Access Compliance Report

Public Rights-of-Way

Main Street: CEDARLAWN_DR Cross Street: SKYMEADOW_DR Location: NE

ADA ID: RPRK210917133850 Ramp Type: Type 1 - Perpendicular Diagonal Initial Pass/Fail: Pass Overall Compliance: No Severity Score: 6

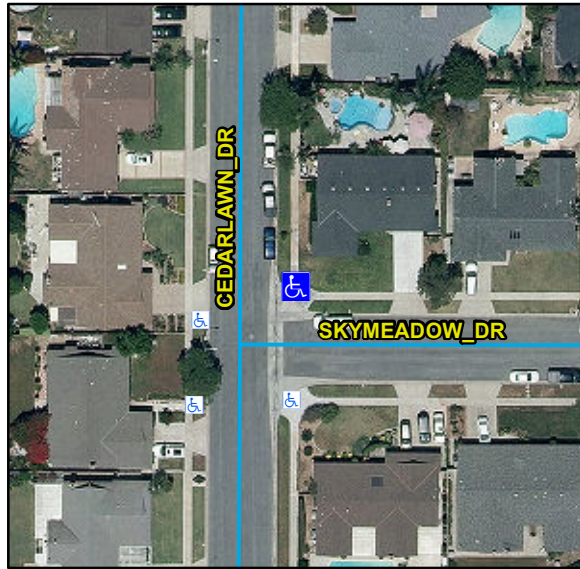
Remove & Replace Landing.

R304.2.1, STD 1115
